ADDENDUM #4

Essexville-Hampton Public Schools
New Innovation Center Project
September 14, 2026

Project: EHPS New Innovation Center Project

RE: Pre-Bid RFI Response

A6.0

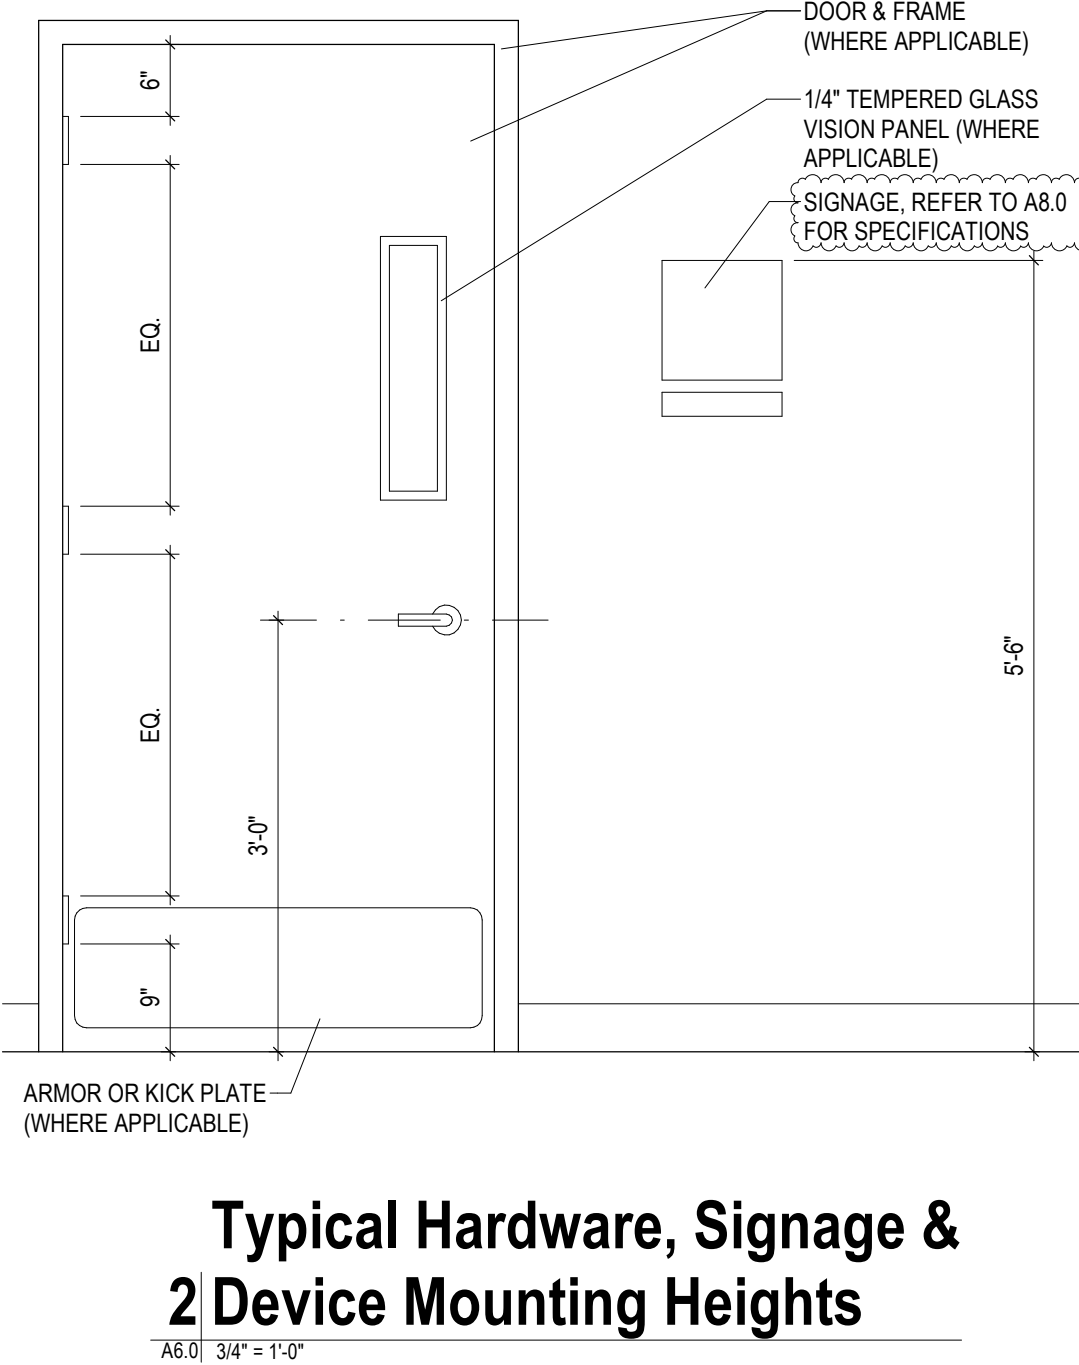
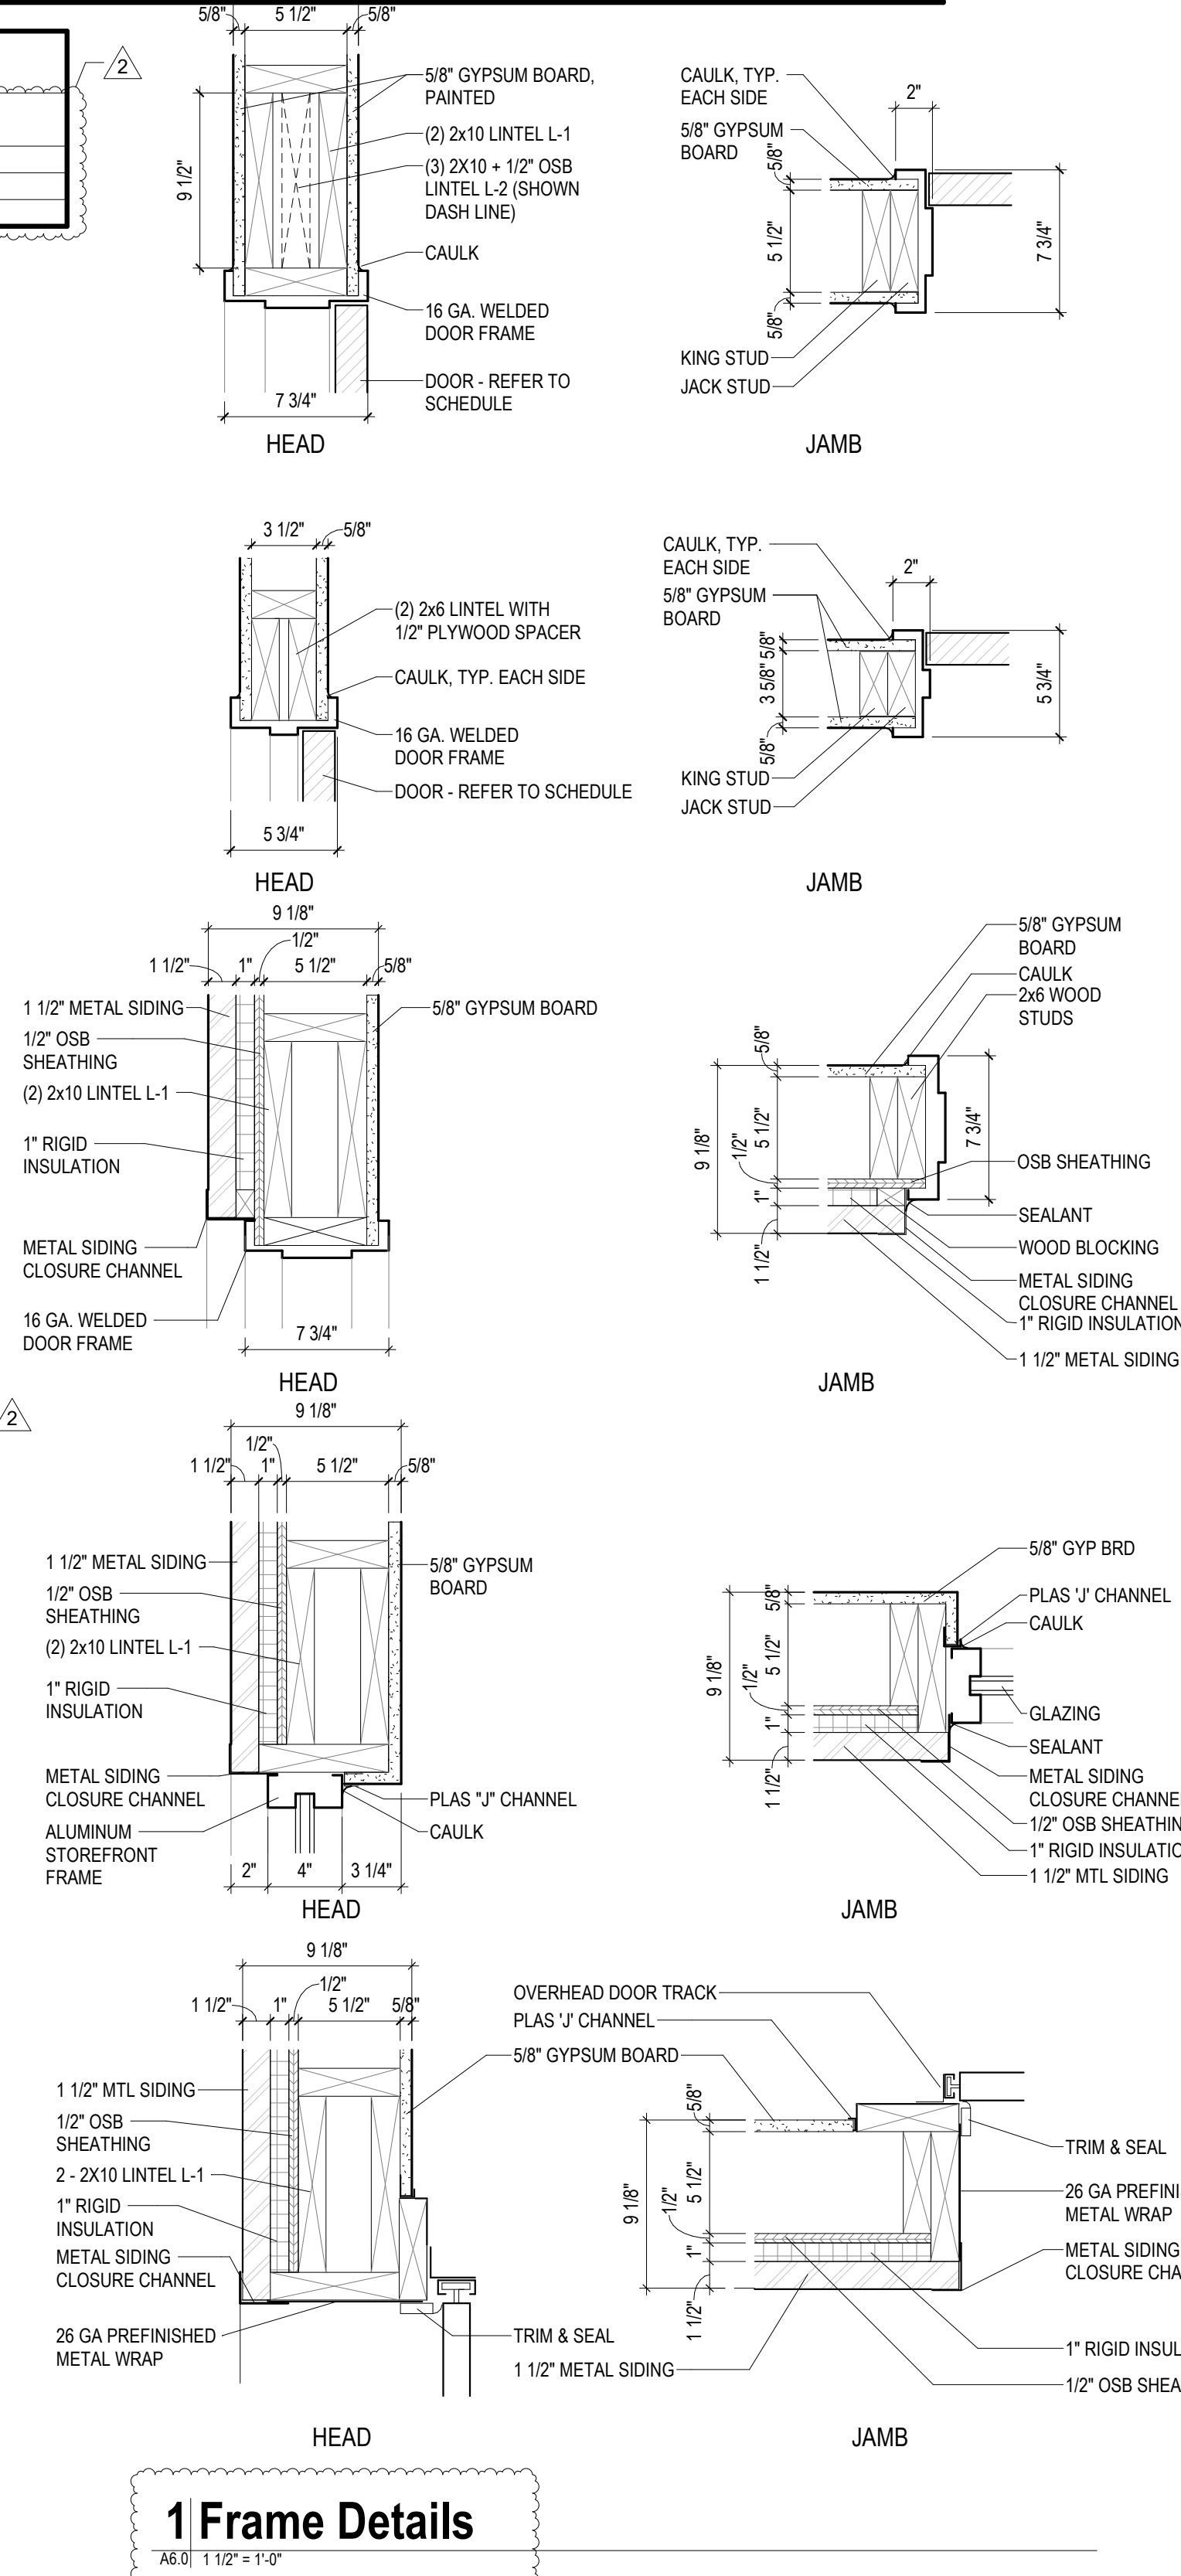
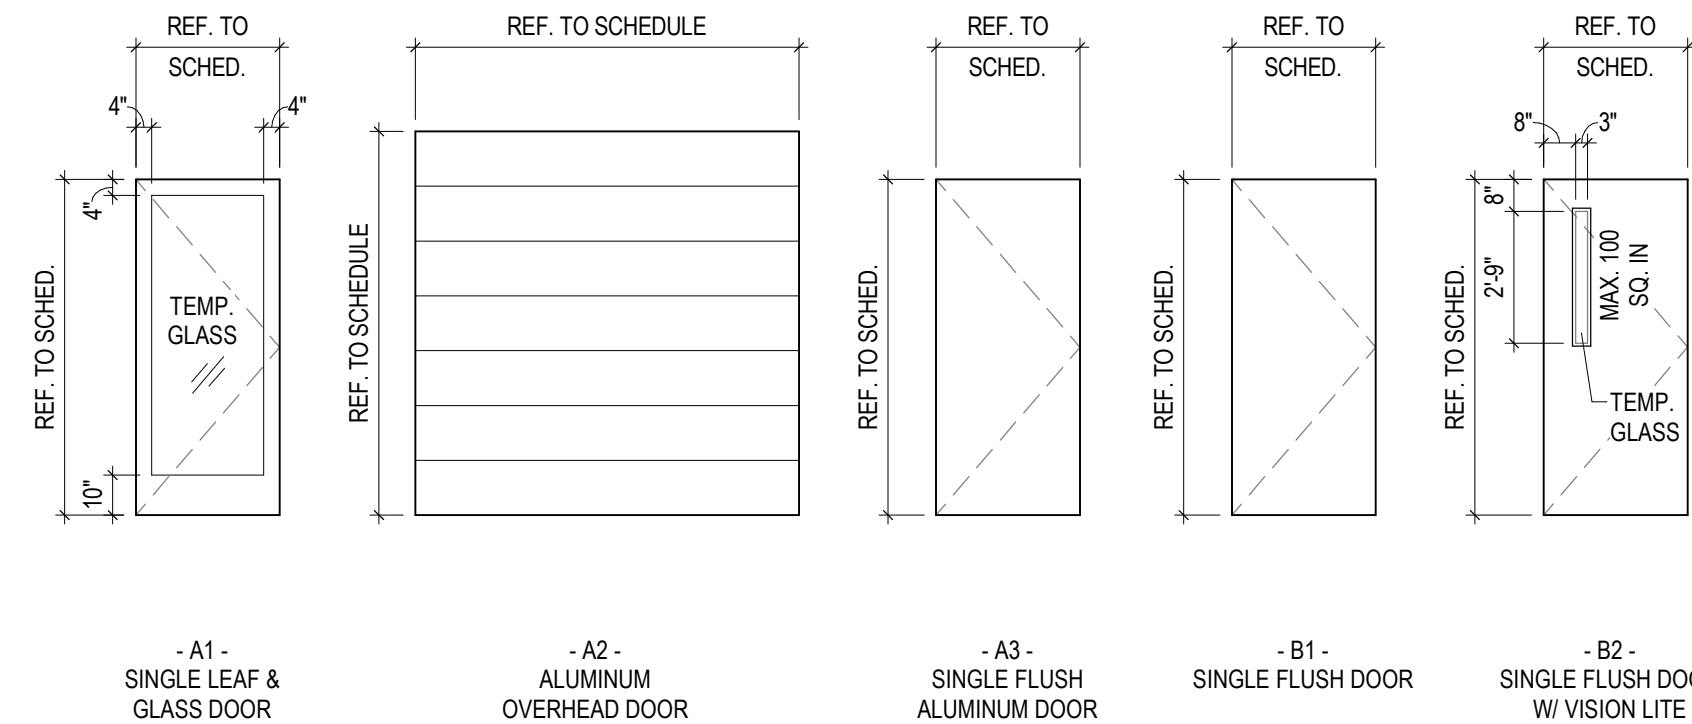
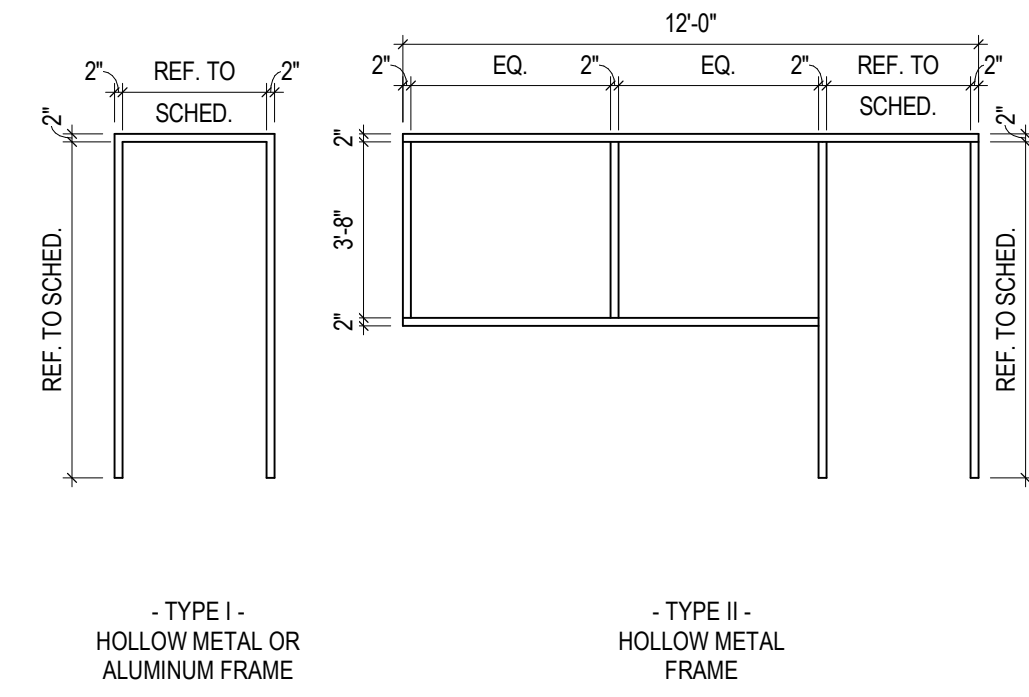
1. Window type A, B and C, are they Aluminum Storefront?
 - a. Yes, aluminum storefront. Refer to updated window schedule and detail 1 on re-issued sheet A6.0.

1. On the room finish schedule they have materials listed, but I need the manufacturer and colors for the carpet-1, carpet-2, carpet -3, vinyl tile, resilient base, and ceramic tile walls.
 - a. Refer to finish schedule on re-issued sheet A6.0.

A6.0 - Door and Frame Types, Door Schedule, Room Schedule, Window Schedules

- a. Updated to include minimum manufacturer and style line for finishes. All material colors to be finalized via shop drawing.

7 Wall Section

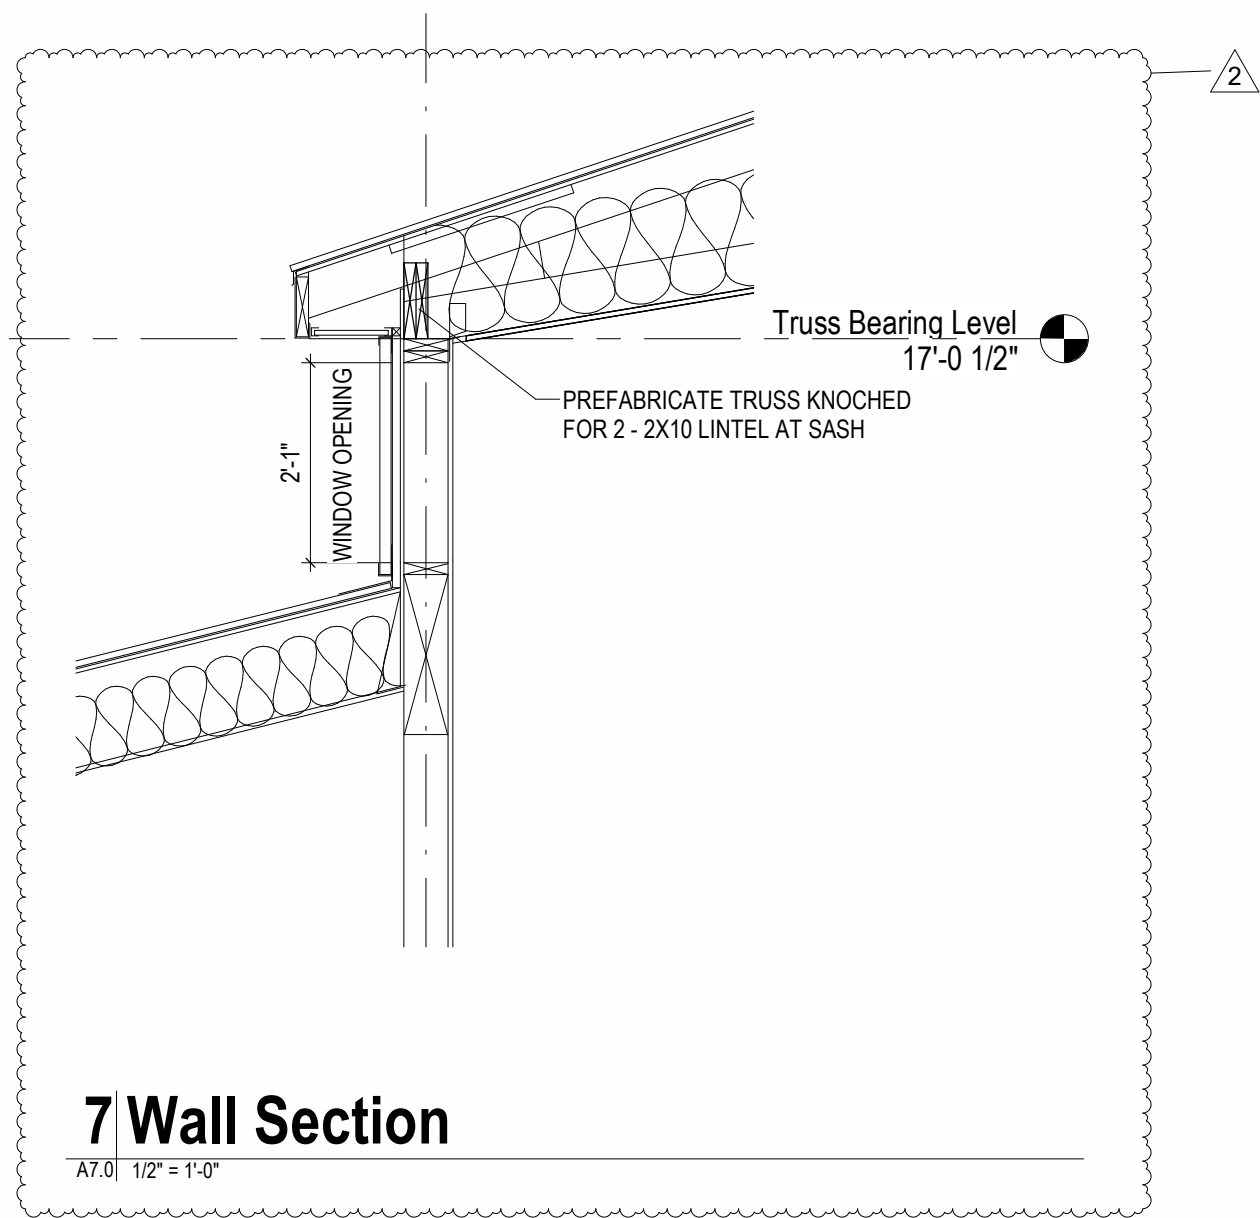
1. I have an RFI regarding the framing detail above the type "C" windows. The way this is currently drawn there is no space for a header to support the truss weight above. Can you please provide a framing detail for these areas.
 - a. See updated detail 7/A7.0 - Wall Sections.
